Re: Amendment to Steep Slope approval
Addition and alteration to
Existing 1 family dwelling
6 Fulton Street
Hastings on Hudson, New York
DAB Job # 160901

Attached please find three (3) copies of As-built Site Plans for review to amend the previously approved Steep Slope application.

Re: Amendment to the Steep slope analysis for
Addition and alteration to
Existing 1 family dwelling
6 Fulton Street
Hastings on Hudson, New York
DAB Job # 160901

Re: Special hardship exception (Section 249-8)
to Steep Slope amended approval for the
Addition and alteration to
Existing 1 family dwelling
6 Fulton Street
Hastings on Hudson, New York
DAB Job # 160901

LANDSCAPING PLAN

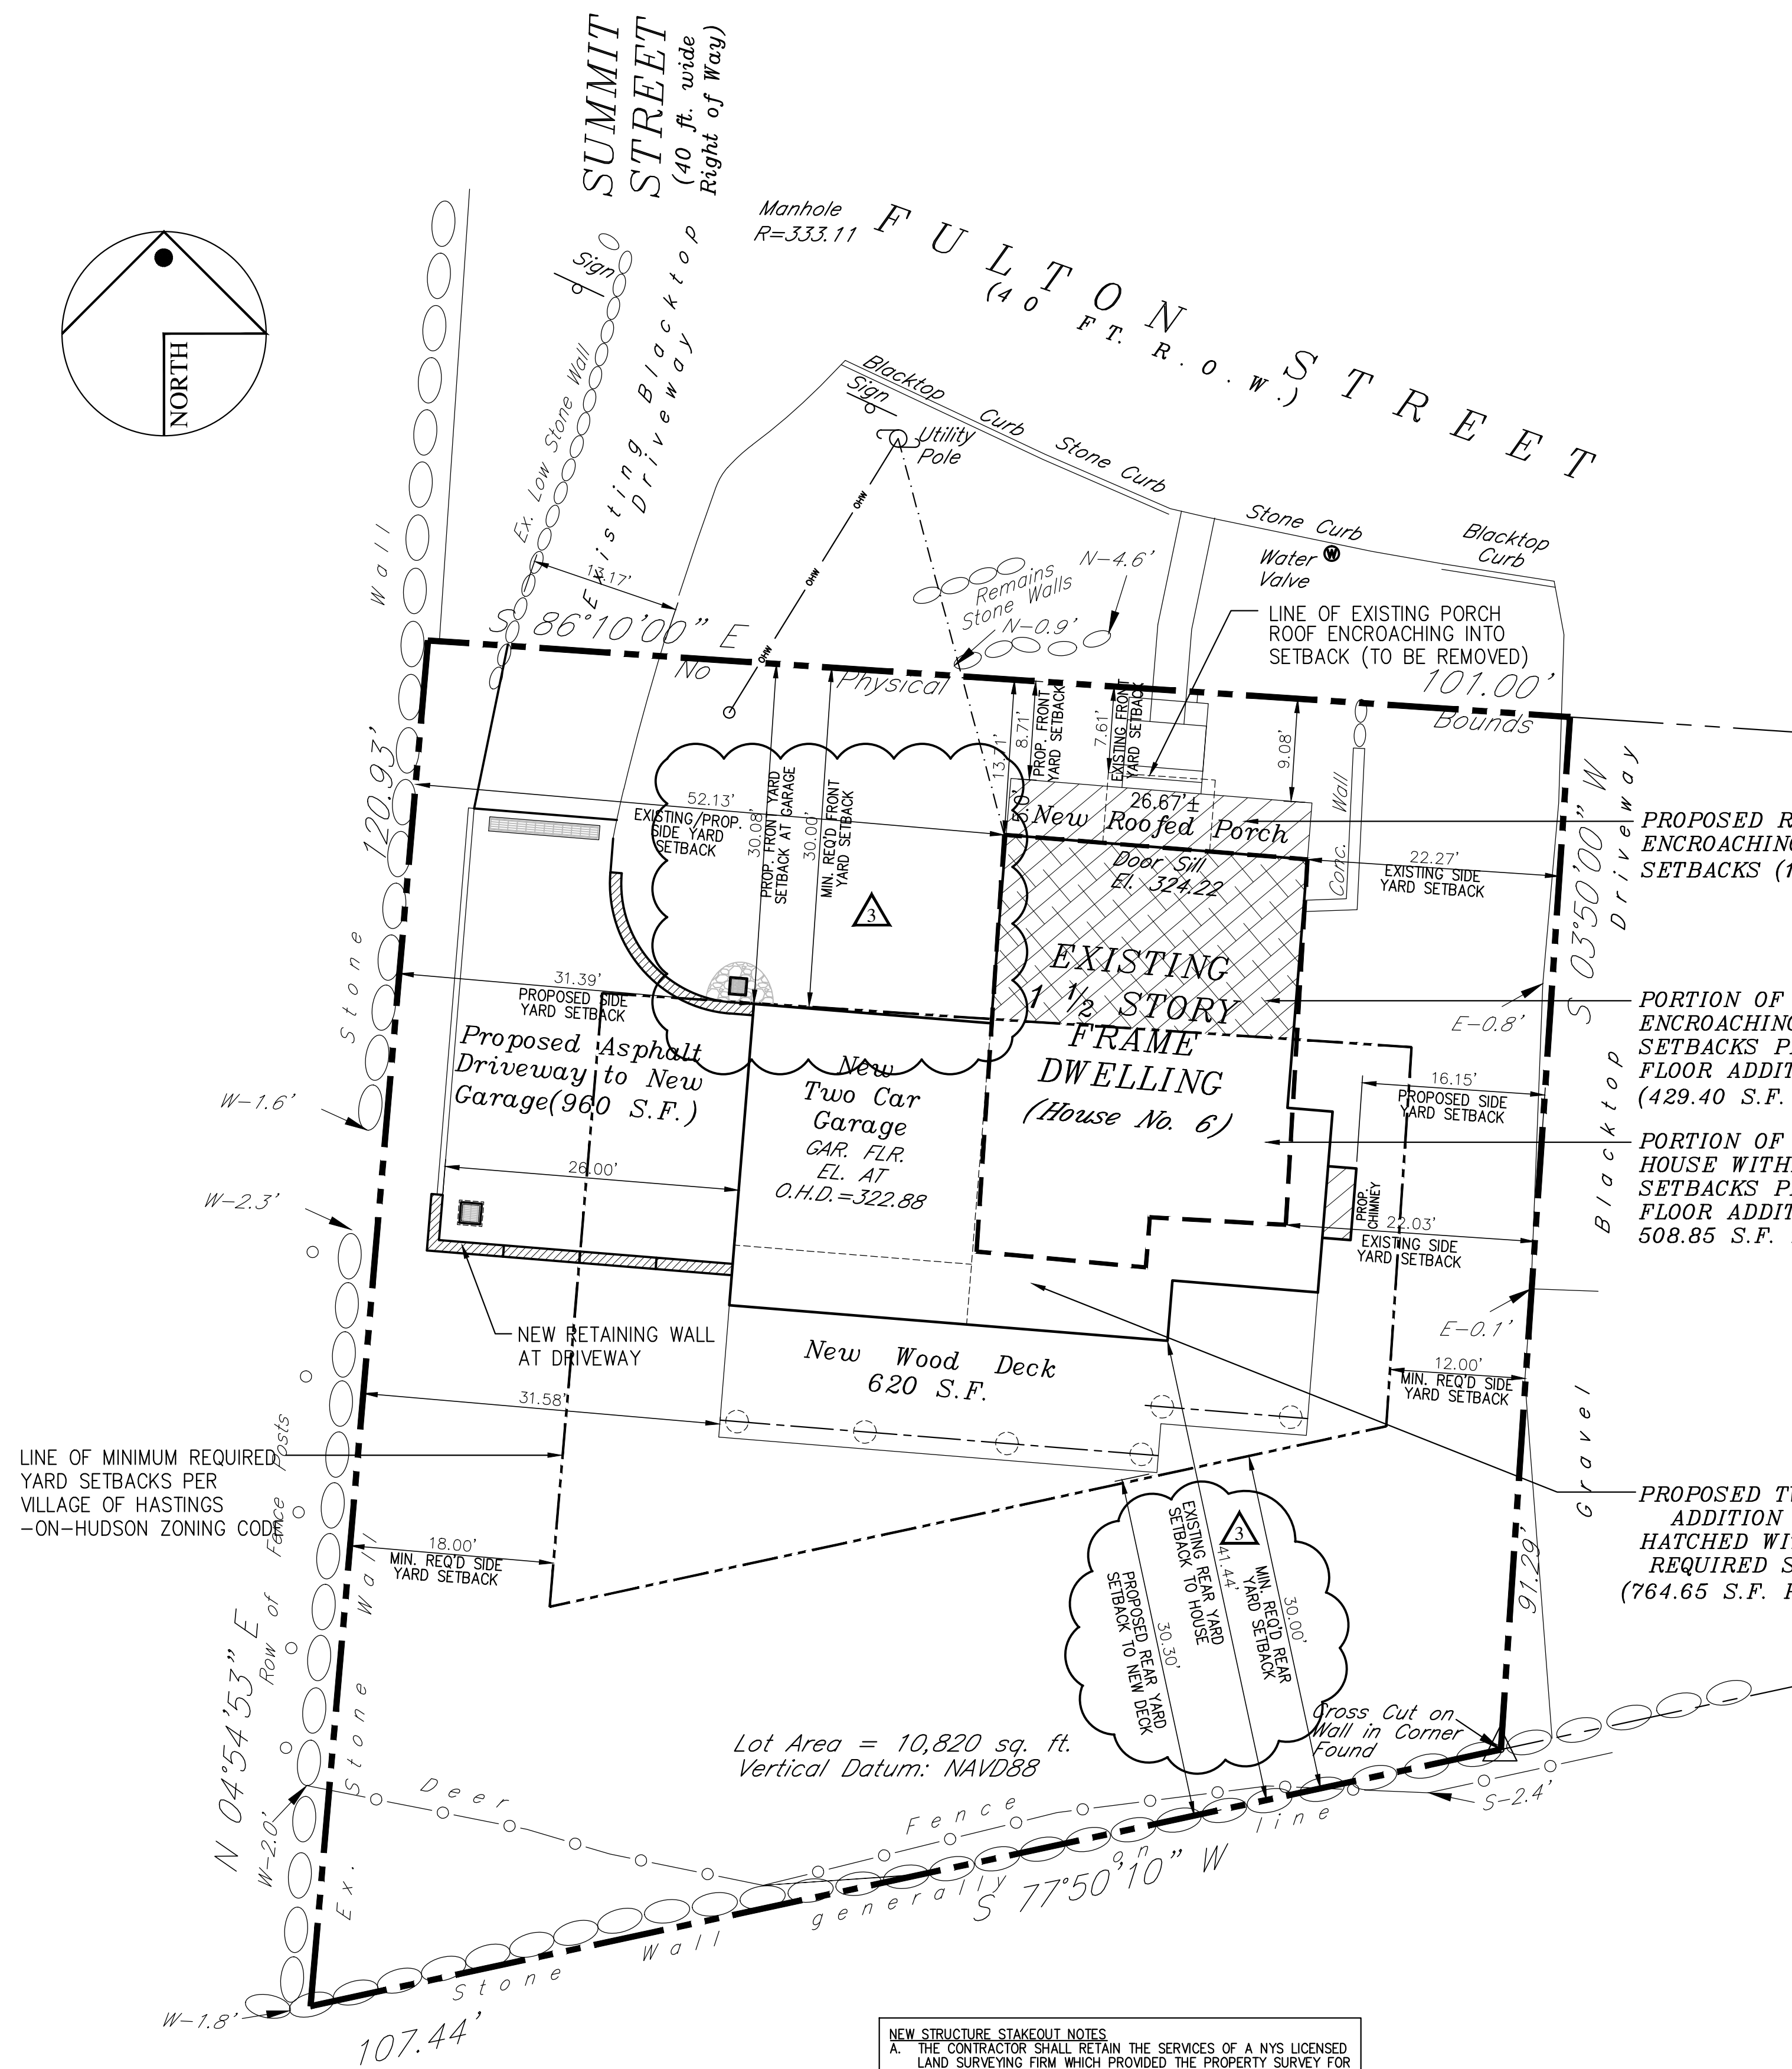
§ 249-7(2)	A landscaping plan for the applicant's property, indicating proposed paved areas, storm drainage facilities, retaining walls and ground cover, as well as the location of trees and ornamental shrubs.	REVISED LANDSC. PLAN PROVIDED
§ 249-7(3)	Architectural plans, elevations, sections of the structures and related improvements.	N/A
§ 249-7(4)	A statement prepared by a licensed architect, registered landscape architect or engineer describing: (a) The methods to be used in overcoming foundation and other structural problems created by slope conditions, in preserving the natural watershed and in preventing soil erosion; (b) The methods to be used to eliminate or mitigate water runoff on all adjacent properties and any other property that will be naturally affected by increased water runoff; and (c) The methods used to minimize the impact of changes in topography on adjacent and nearby properties through landscaping, retaining walls and terracing of gardens	A LETTER PREPARED BY ARCHITECT ADDRESSING THESE ITEMS IS PROVIDED

Slope Analysis added Oct. 18, 2016 & Nov. 9, 2016.

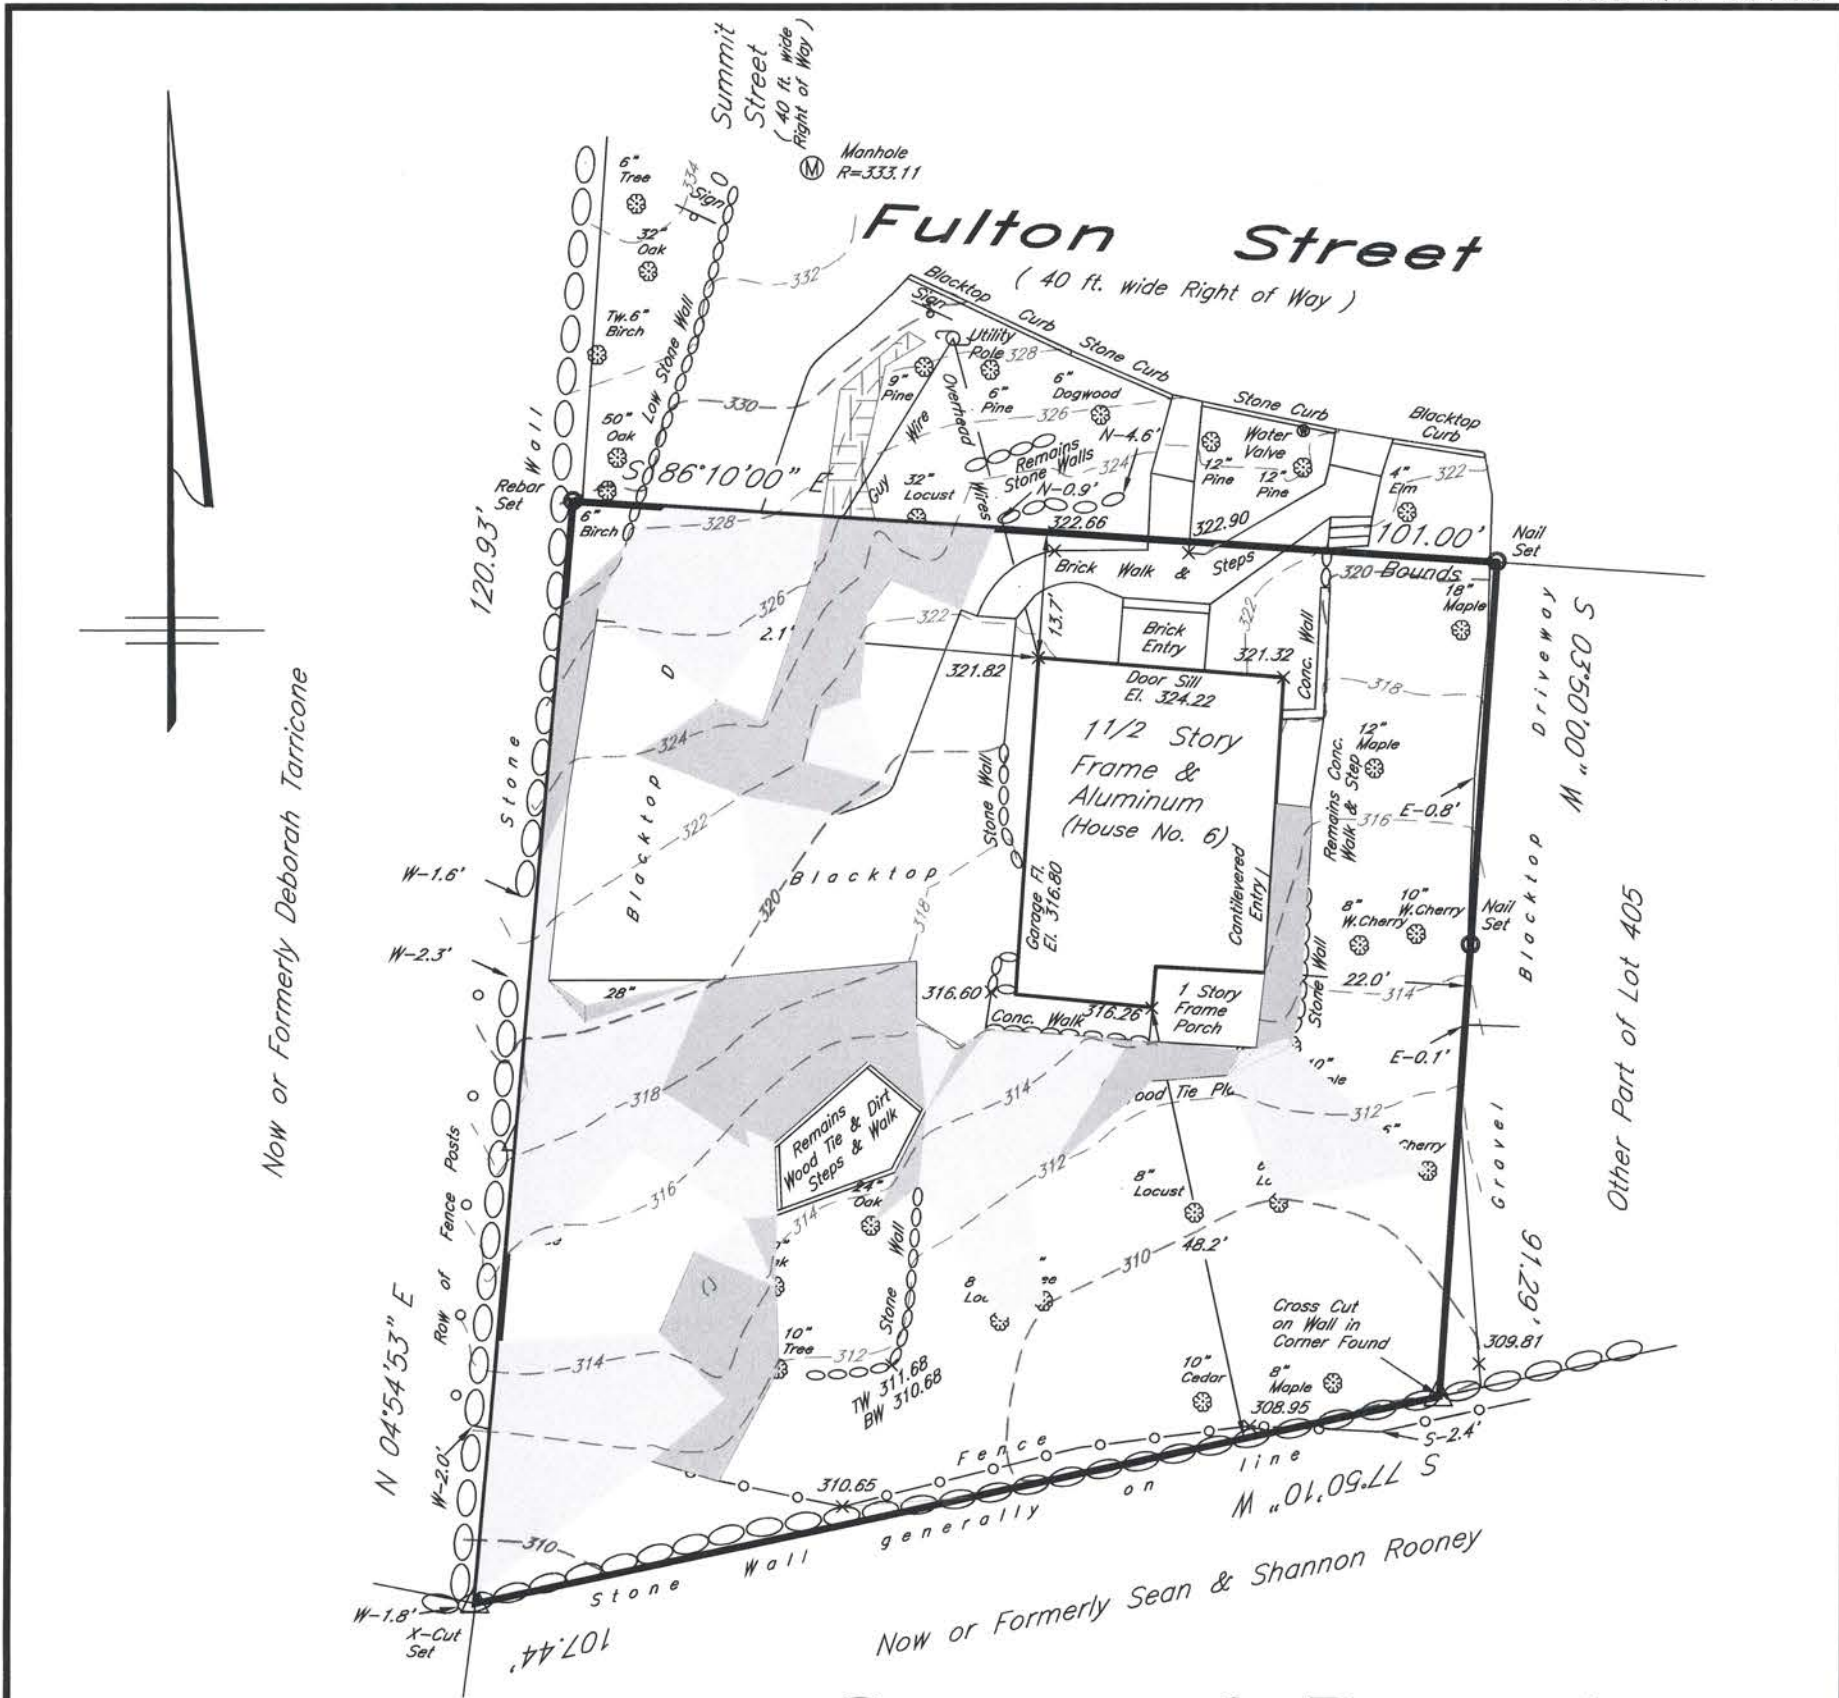
Pursuant to Chapter 249, *Steep Slopes*, the following is an analysis of steep slope disturbances per **249-5 A** and **B**. (as-built values are indicated in red)

A. **Slopes in excess of 15% but not greater than 25%; max disturbance shall not total more than 35%.**

As-Built conditions

Total slope area (15%-25%) = **3,277 sq. ft. total.**

Total disturbed area (developed/paved, or regraded) = **1,518 sq. ft.**

Percentage of developed area in 15%-25% sloped area = $3,277/1,518 = 46.3\% > 35\%$

B. **Slopes in excess of 25%; max disturbance shall not total more than 25%.**

As-Built conditions

Total slope area (excess of 25%) = **1,444 sq. ft. total.**

Total disturbed area (developed paved, or regraded) = **515 sq. ft.**

Percentage of developed area in excess of 25% sloped area = $1,444/515 = 35.6\% > 25\%$

Pursuant to Section 249-8 Special hardship exception of the Steep Slope chapter of the Village Code, we are respectfully requesting that the Planning Board grant a hardship exemption to the requirements of Section 249-5 A and B of the Steep Slope chapter for the following reasons:

- A. The lot cannot be developed without disturbing more than the percentage limits in Section 249-5.

Under the original application approval, the referenced property was under the values as prescribed in 249-5. The values changed as a result of the contractor regrading the rear of the property, thus modifying the Steep Slope areas. The values indicated on the Steep Slope Survey, prepared by Ward Carpenter Land Surveyors depicts the increased areas in the 15%-25% slope areas (increased 1,140 sq. ft.), and in the 25% and greater slope areas (increased 199 sq. ft.); these increased areas were taken from the 0%-15% slope areas. This is a result of the contractor's inexperience in understanding and dealing with the Steep Slope requirements.
